APA Technical Note - Western Outer Ring Main - Environment Effects Statement

TECHNICAL NOTE NUMBER: TN33

SUBJECT: Jacksons Creek construction timing options update

SUMMARY This Technical Note provides an update to the construction timing options for Jacksons Creek crossing assessed in the Western Outer Ring Main (WORM) Environment Effects Statement (EES).

Figure 1 Construction methodology – Option 2

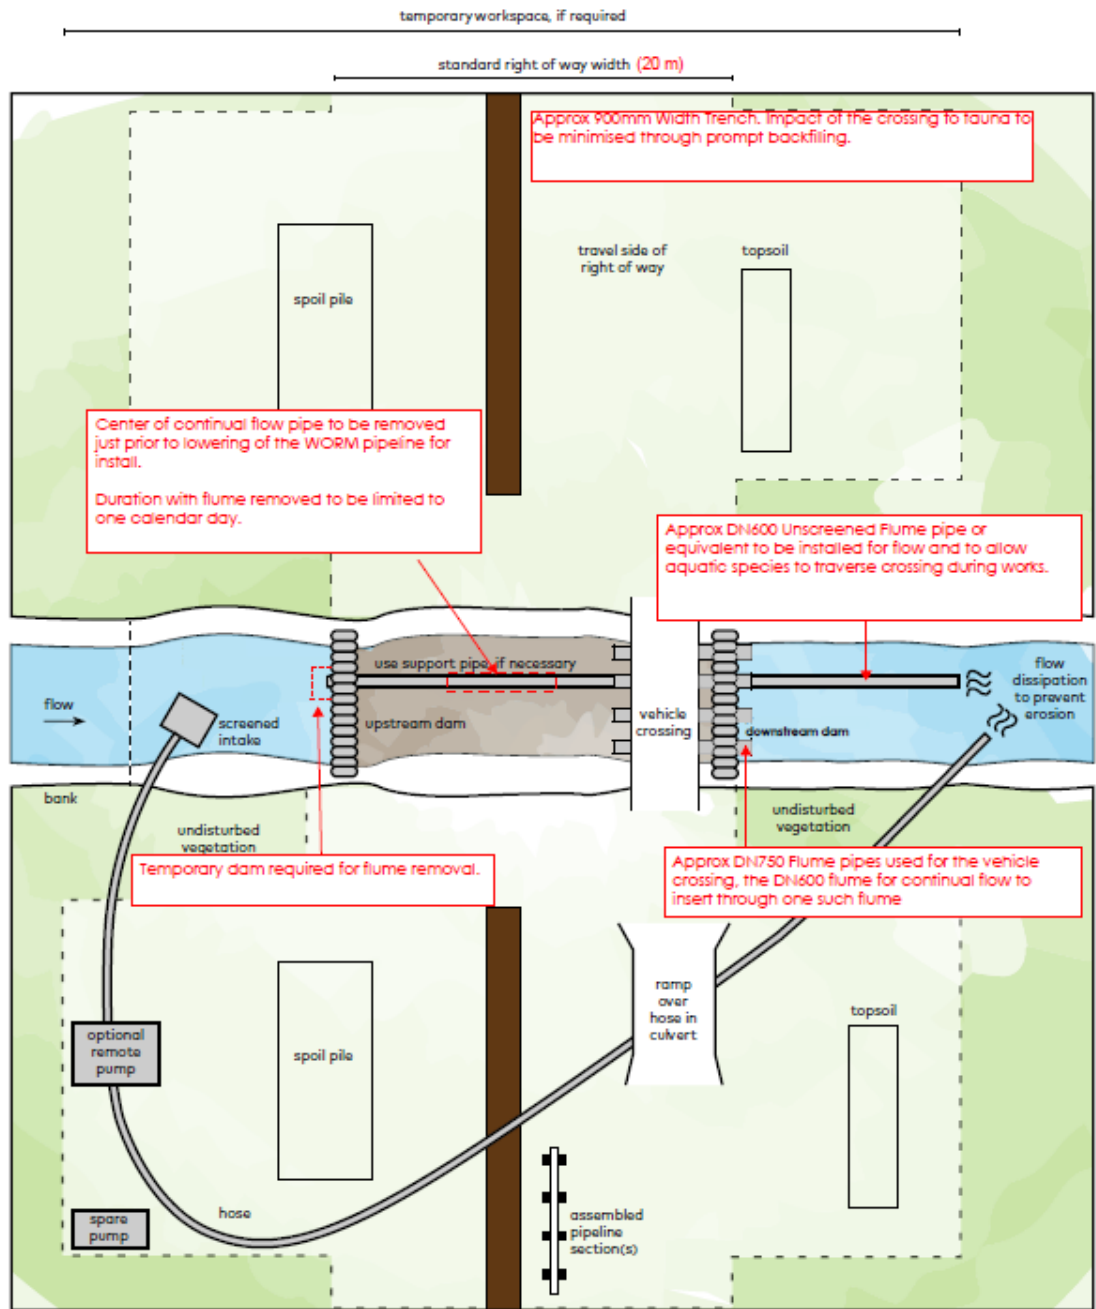
| | Option 1 – Presented within the EES Exhibited Report | Option 2 – Proposed changes to construction timing |
|---|---|---|
| Work methodology (Refer to attached figure) | Details of work methods presented in EES Chapter 3 <i>Project description</i> | The following methods are proposed, subject to weather, ground conditions or other site related issues: <ul style="list-style-type: none"> ■ Pipeline is to be installed up to the creek bank and backfilled promptly, allowing species mobility over land. ■ Removal of vegetation adjacent to bank on southern side: 2-3 days. ■ Access Track installation with approximately 4 x DN750 flume to not impede flow: 2-3 days ■ Dam and continual flow flume installation: 1 day ■ Trenching the crossing: 5 days with rock anticipated ■ Removal of continual flow flume and lowering of pipe into crossing: 1 working day (maximum duration for flow impedence) ■ Backfilling and removal of dam: 1 working day (concurrent with lowering and tie-in welding) ■ Bank reinstatement: 5 days |

5 Figure 1 provides an overview of the amended construction methodology for Jacksons Creek with consideration of undertaking works described in Option 2.
